SERVICE INSTRUCTIONS

No. 1219
ATA Code 32-40

SUBJECT: LANDING GEAR - INSTALLATION OF 17.5 INCH DIAMETER TIRES AND MODIFICATION OF BRAKE ASSEMBLIES

EFFECTIVITY: BEEHCRAFT Skipper 77, serials WA-1 through WA-312.

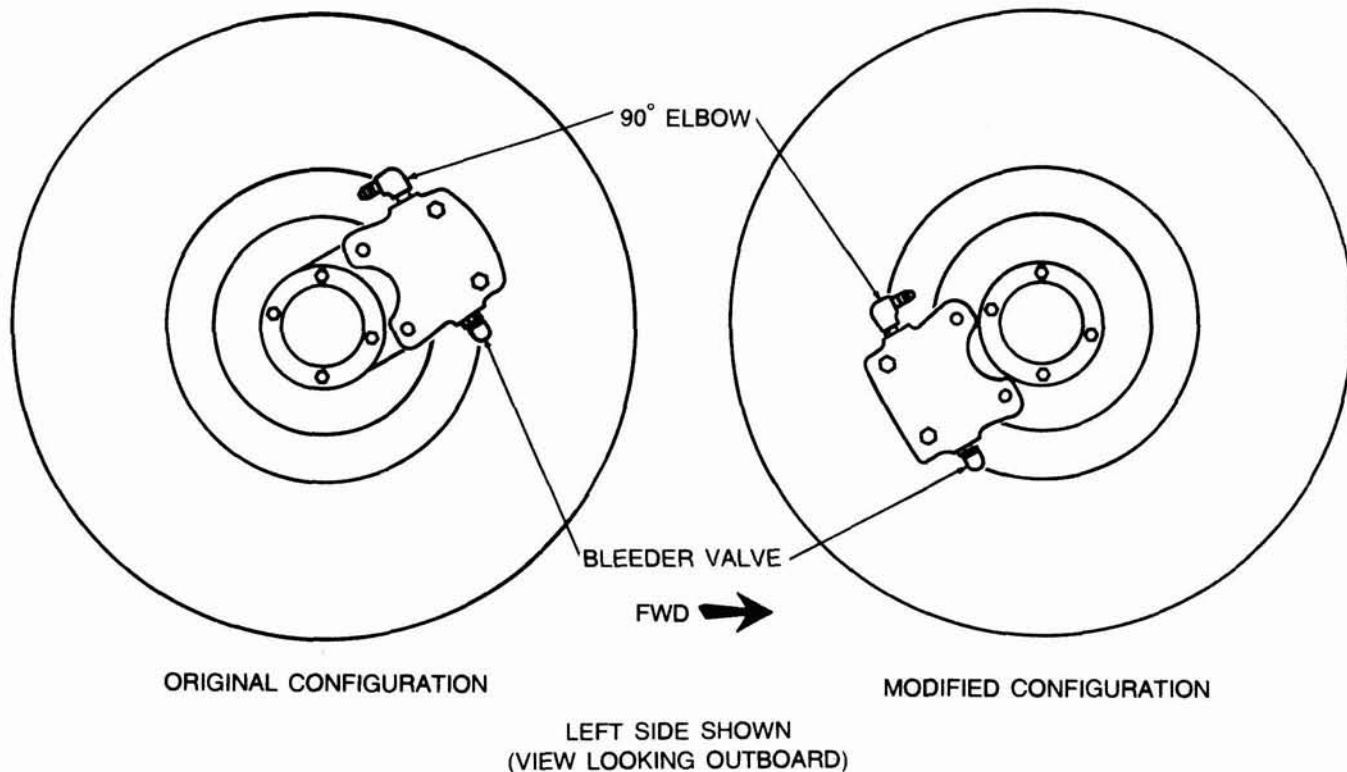
1. Refer to the Maintenance Manual, Chapter 7-00 to jack the airplane and cradle the wing.
2. Refer to the Maintenance Manual, Chapter 32-40 and remove the wheel/tire and brake assembly.
3. Rotate the brake assembly 180° about the axle spindle and reinstall to the strut (see illustration). Torque the attaching bolts to 75 - 80 inch-pounds.
4. Remove the 90° elbow fitting and bleeder

assembly and reinstall with the bleeder in the bottom of the brake housing and the 90° elbow fitting in the top of the brake housing (see illustration). Seal only the pipe thread of the 90° elbow fitting and bleeder assembly with teflon tape.
